RESOURCE CONSENT RMA/2022/3611 – RFI RESPONSE LAND USE AND SUBDIVISION APPLICATION 320 AND 320A CUMNOR TERRACE, CHRISTCHURCH

1. This letter responds to the further information Council requested on 18 January 2023 in respect of the above resource consent application.
2. The following response is organised under the same headings with the items reproduced in grey text.

APPENDIX 1 - LANDSCAPE RFI PORTLINK INDUSTRIAL SUBDIVISION

B. ESPLANADE ECOLOGICAL PRINCIPLES PLAN (3) (N.T.S)

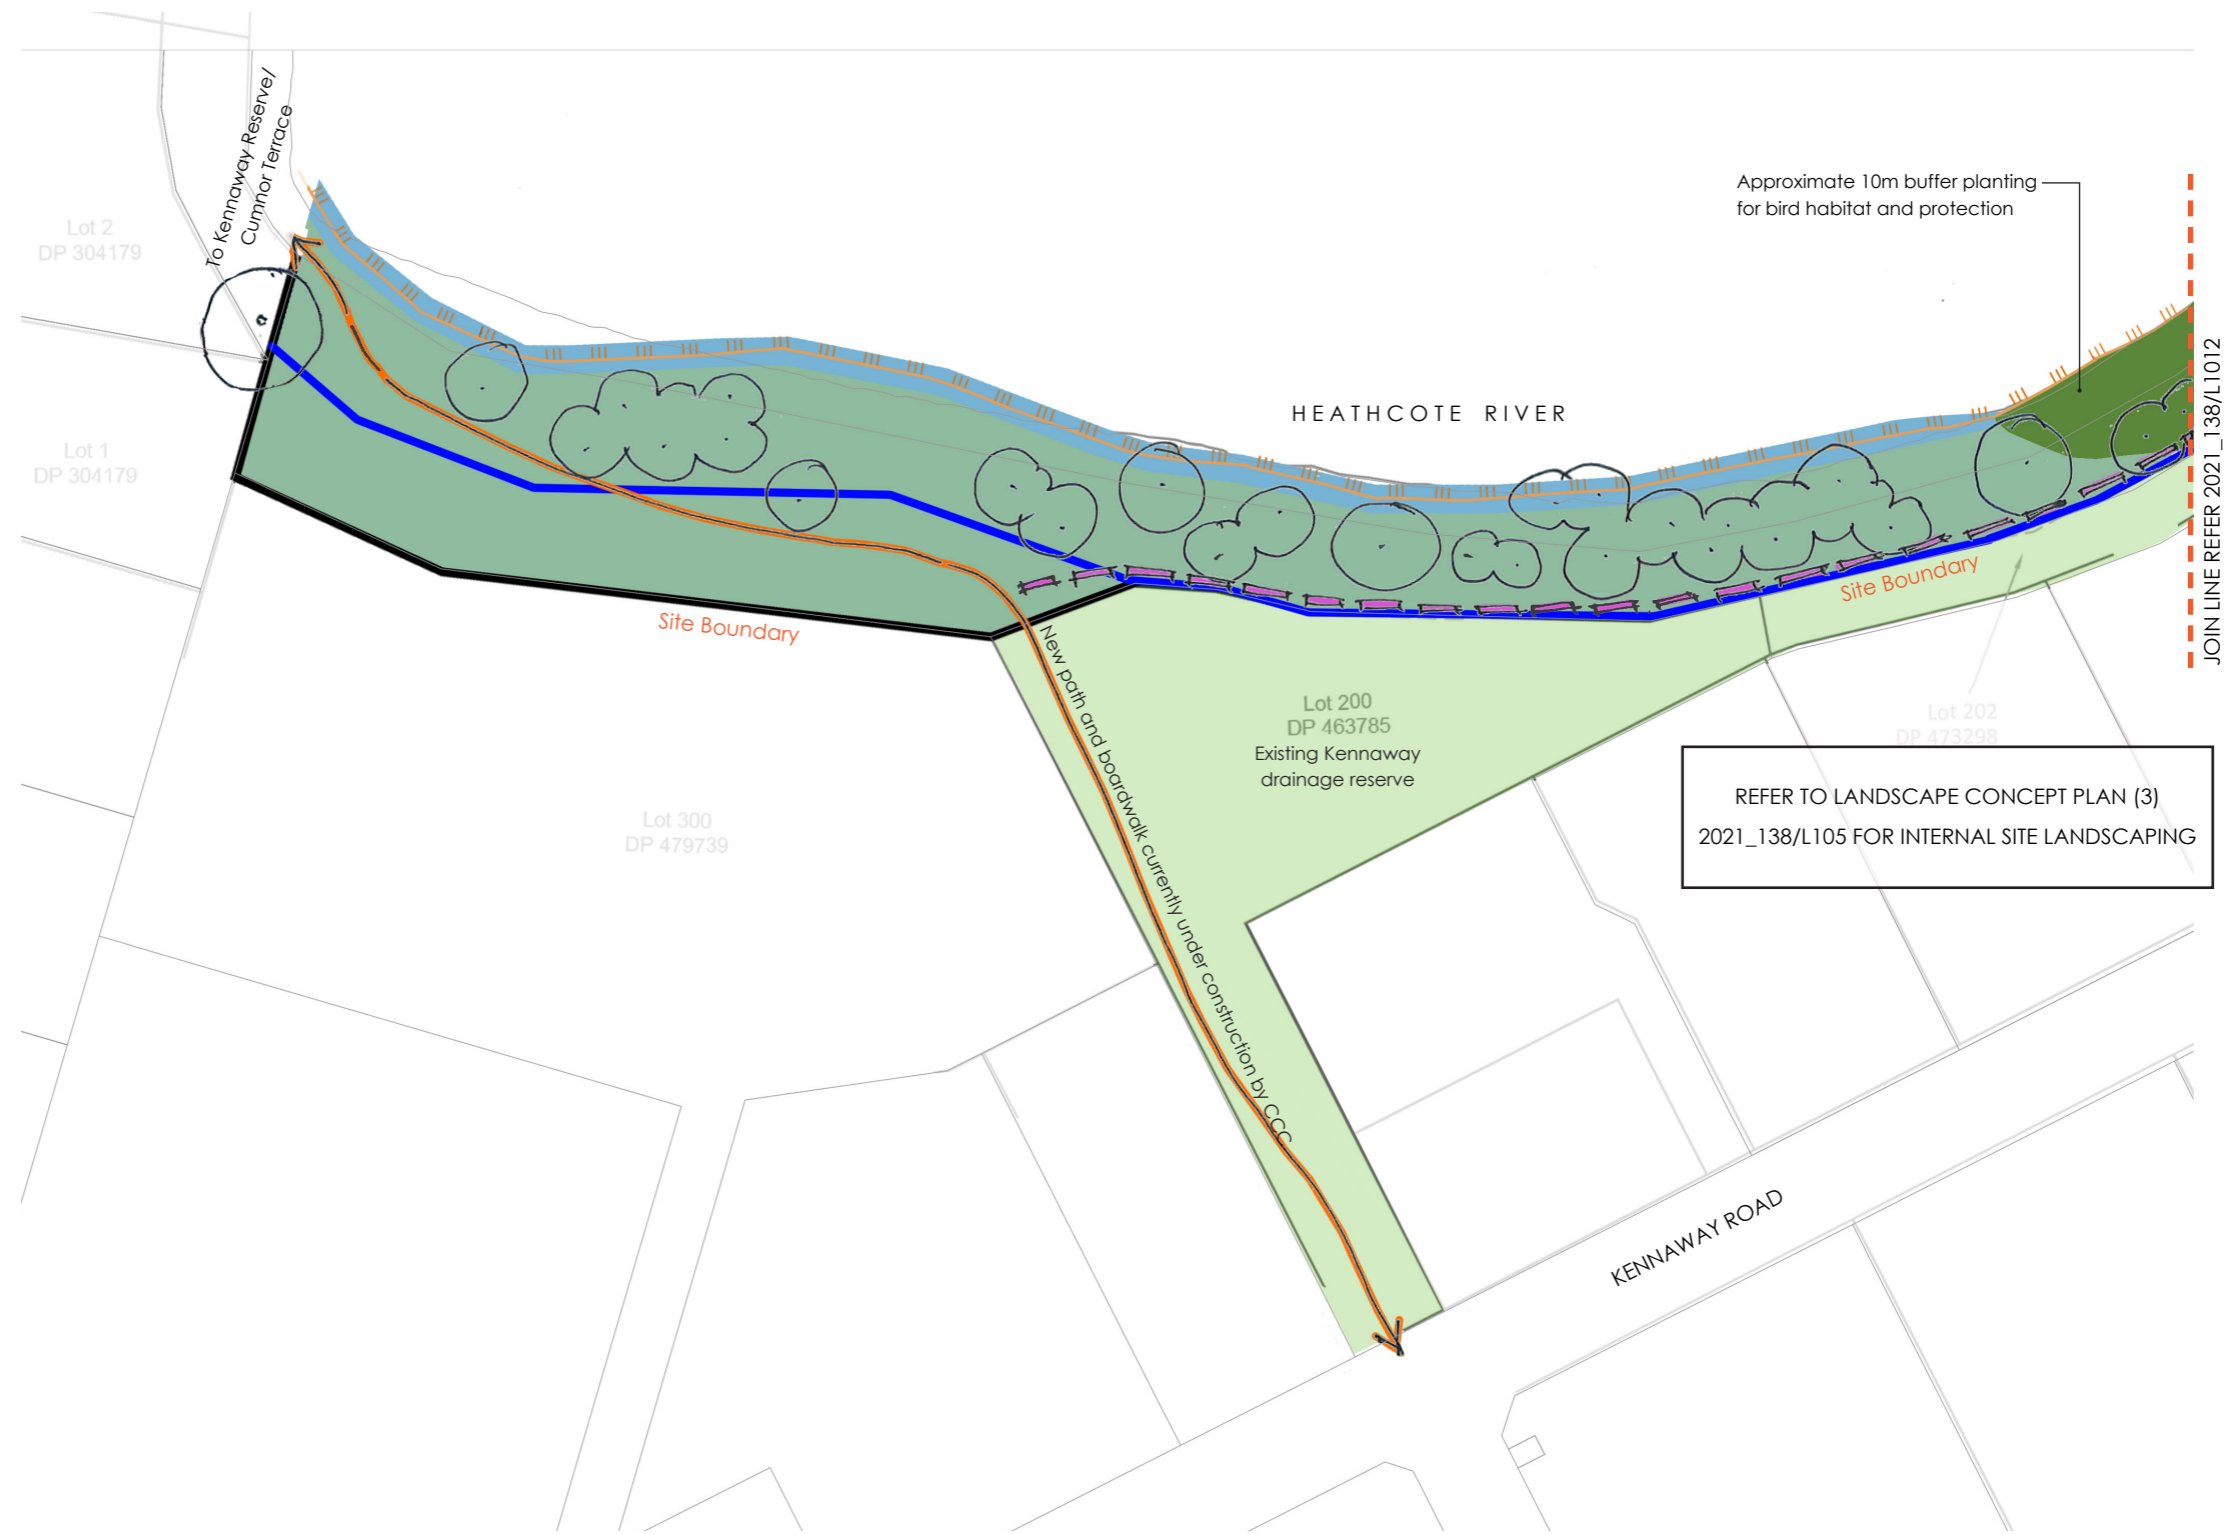
Please provide an assessment from a suitably qualified and experienced ecologist, which assesses the suitability of the works in, and landscape plans of, the proposed reserves to:

- *Retain and protect lizard habitat and populations as per the report attached in the application;*
- *Provide habitat, protect existing habitat and nesting/breeding areas for avifauna (this will require an updated bird assessment to that referred to below) and a bird management plan;*

- Provide robust riparian margins to protect both aquatic and terrestrial ecology

42. Please see the response from DCM below:

Changes to the landscape concept affect planting on the northern bund face, where lizard habitat likely exists in this area. Based on herpetological advice, the planting of the bund face is proposed to change to lower growing species suitable for lizard habitat – whereas taller vegetation may (over time) overhang and shade out this habitat, which is not favourable for lizards. The crest and southern side of the bund remains planted for visual screening purpose and provides an approximate 5m vegetation buffer for screening. The change does not alter the findings of the visual assessment.
